Access Compliance Report Public Rights-of-Way (Pedestrian Signals)

Main Street: LOS Alamitos Blvd Cross Street: ROSSMOOR Way Location: SW

ADA ID: SGRK211217131008 Signal Type: One Push Button-Non APS Overall Compliance: No Severity Scores: BTN 1: 10 BTN 2: N/A No BTN: N/A

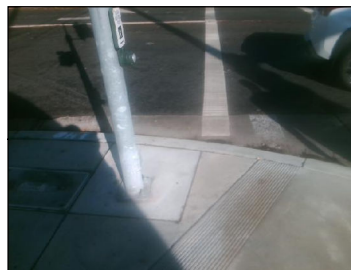
OC Std/PROW: MUTCD 4e.08

Possible Solutions: Replace Signal Push Button With APS Button.
